Industry/TSTF Standard Technical Specification Change Traveler

Change title of "Spent Fuel Assembly Storage" to "Spent Fuel Pool Storage"

TSTF-255,
Rev. 1

Figure 3.7.16-1 (page 1 of 1)
 Burnup versus Enrichment Curve for
 Spent Fuel Storage Racks

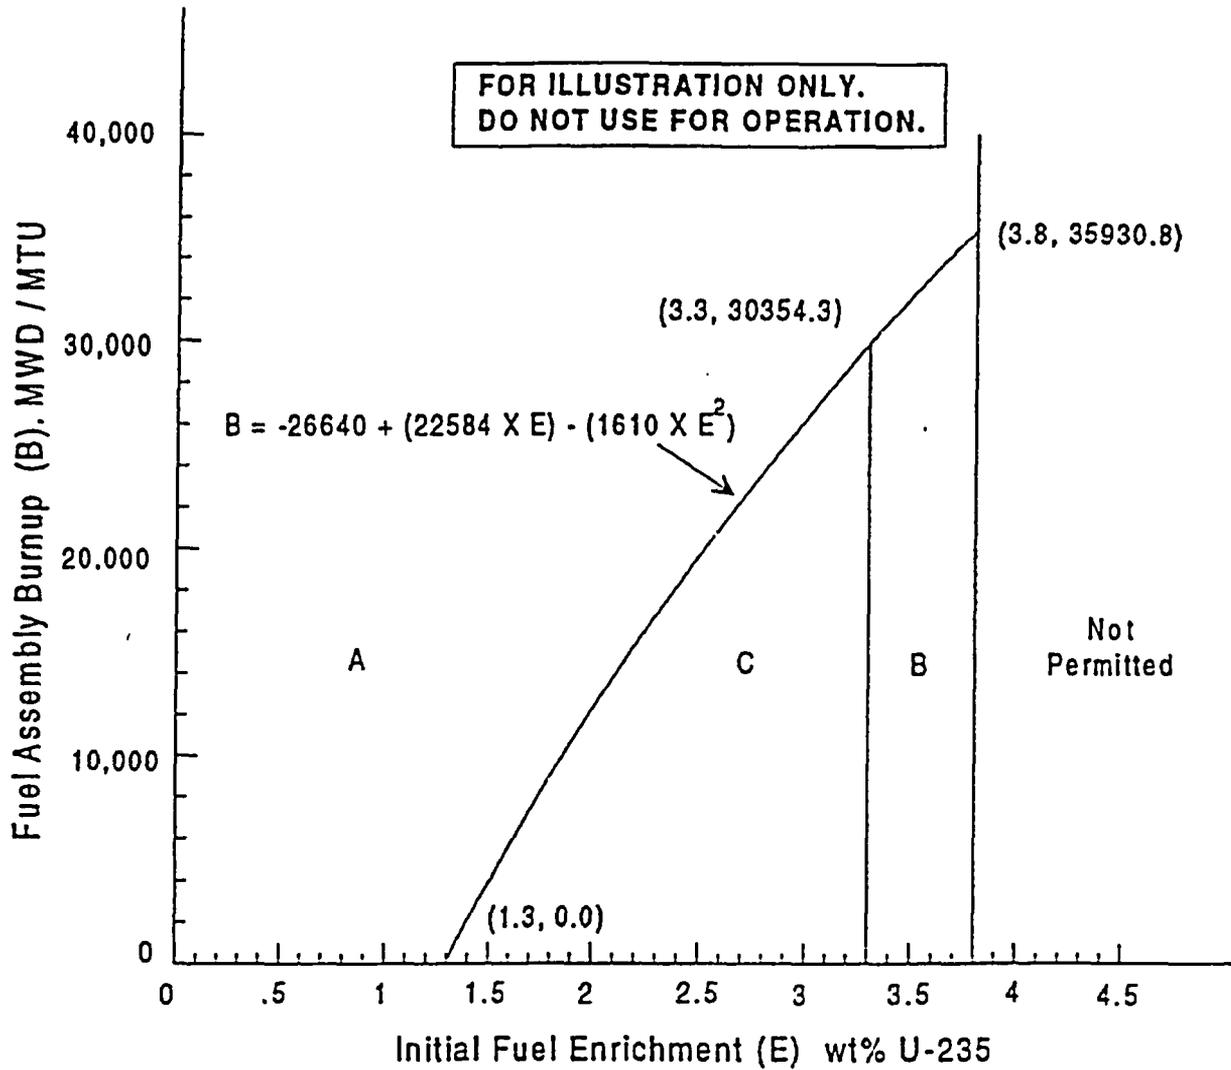
3.7.16 Spent Fuel ~~Assembly~~ Storage

LCO 3.7.16 The combination of initial enrichment and burnup of each ~~spent~~ fuel assembly stored in [Region 2] shall be within the acceptable [burnup domain] of Figure 3.7.16-1 or in accordance with Specification 4.3.1.1.

Figure 3.7.17-1 (page 1 of 1)
Fuel Assembly Burnup Limits in Region 2

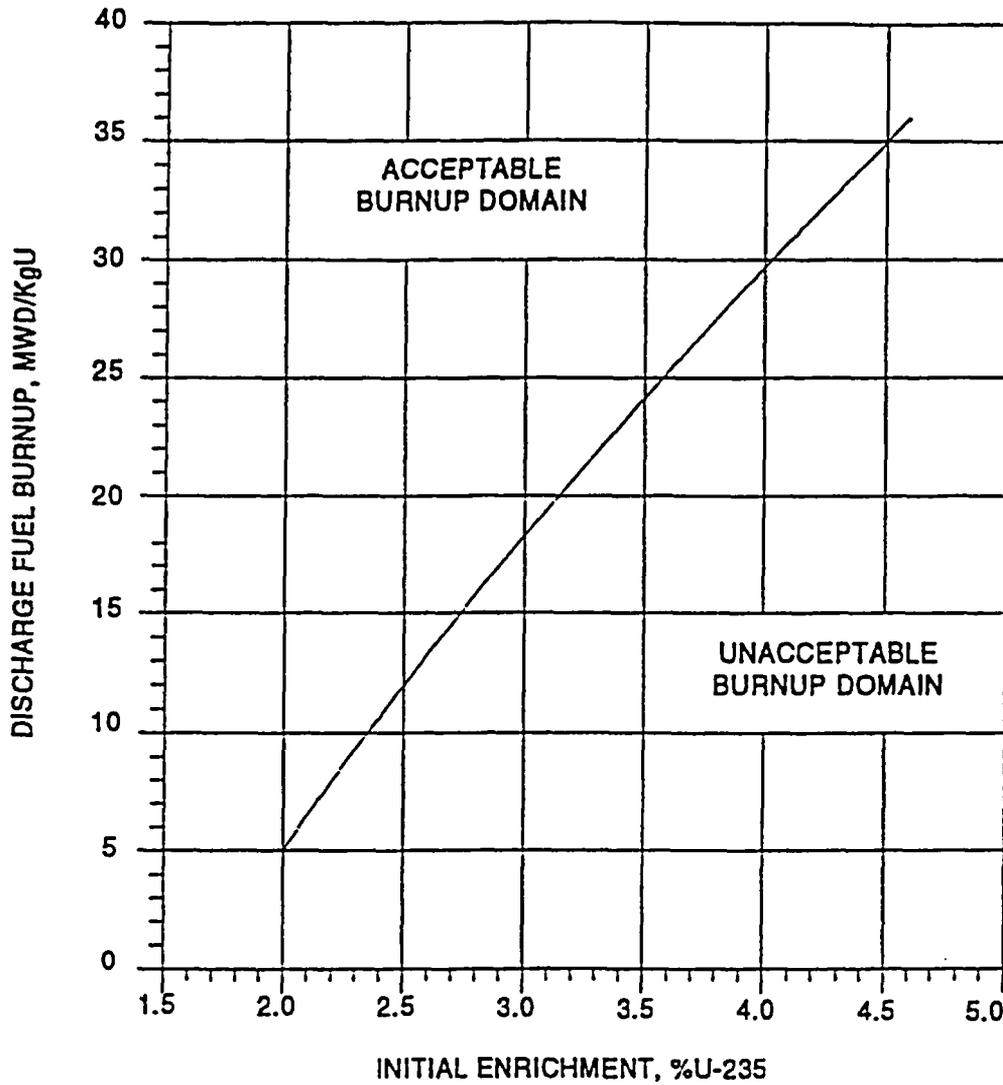
LCO 3.7.17 The combination of initial enrichment and burnup of each spent fuel assembly stored in [Region 2] shall be within the Acceptable [Burnup Domain] of Figure 3.7.17-1 or in accordance with Specification 4.3.1.1.

Figure 3.7.18-1 (page 1 of 1)
Discharge Burnup vs. Initial Enrichment for Region II Racks

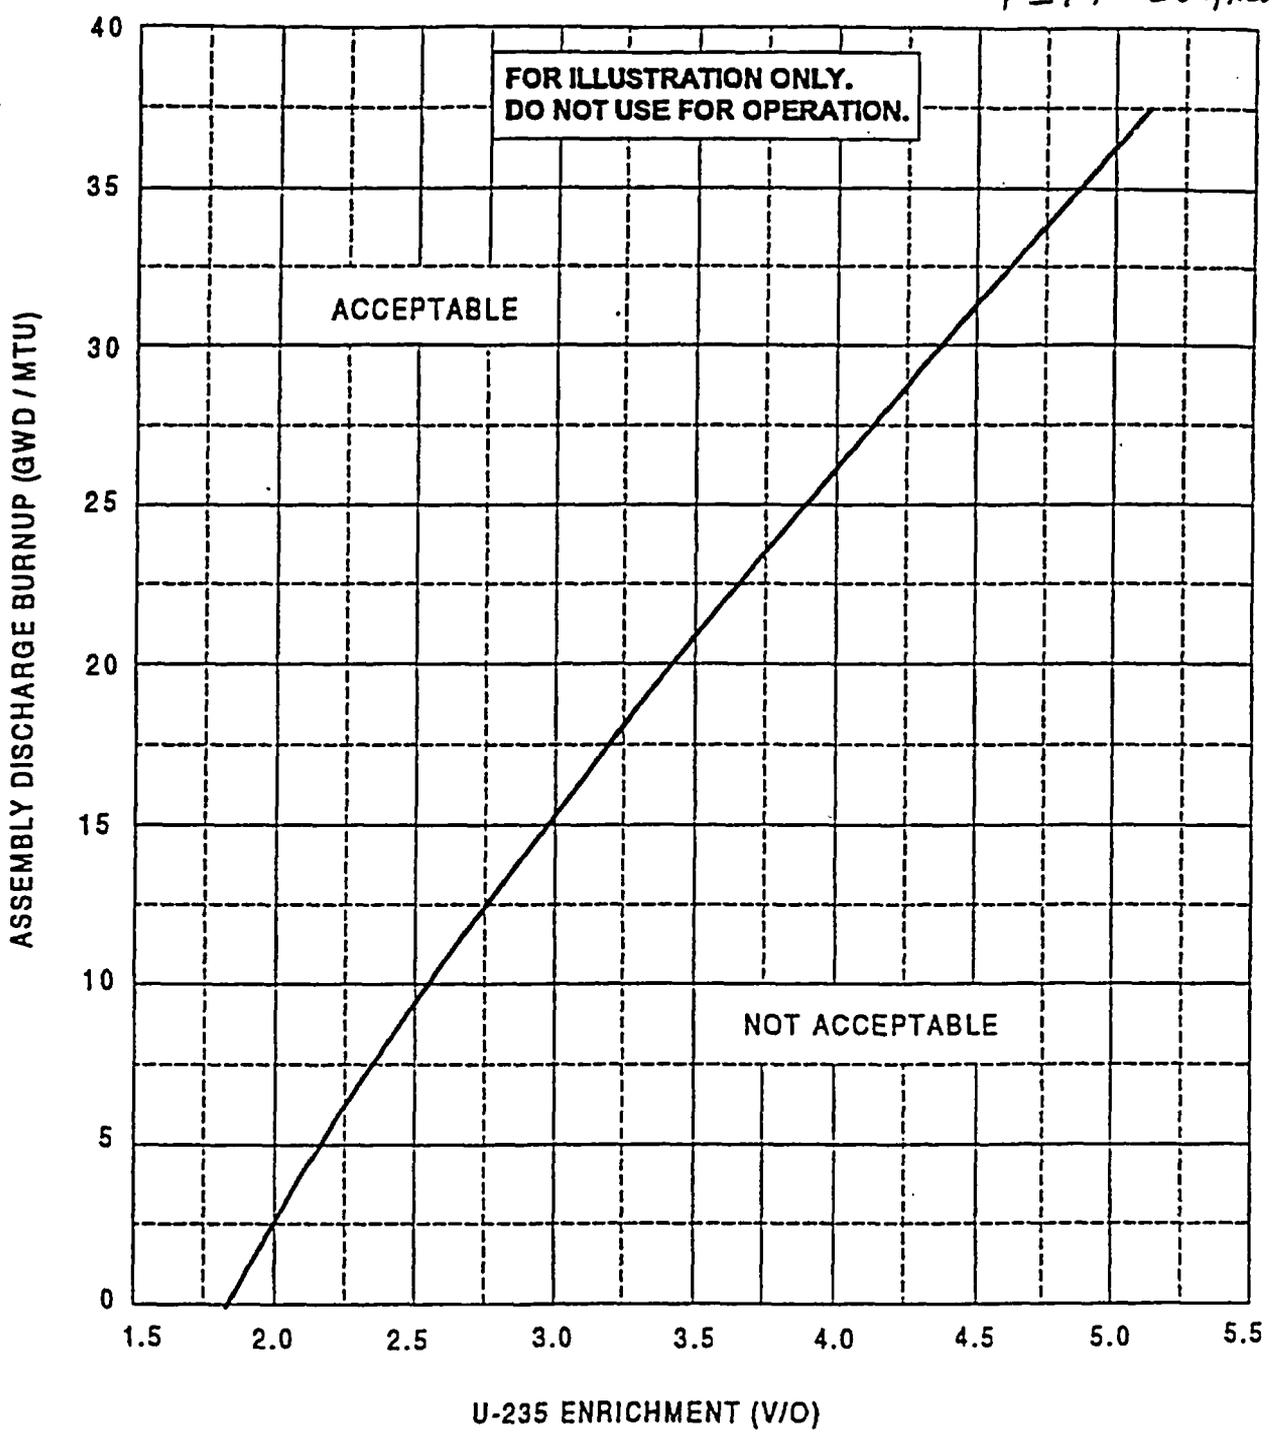
3.7.18 Spent Fuel ~~Assembly~~ Storage

LCO 3.7.18 The combination of initial enrichment and burnup of each ~~spent~~ fuel assembly stored in [Region 2] shall be within the acceptable [burnup domain] of Figure 3.7.18-1 [or in accordance with Specification 4.3.1.1].
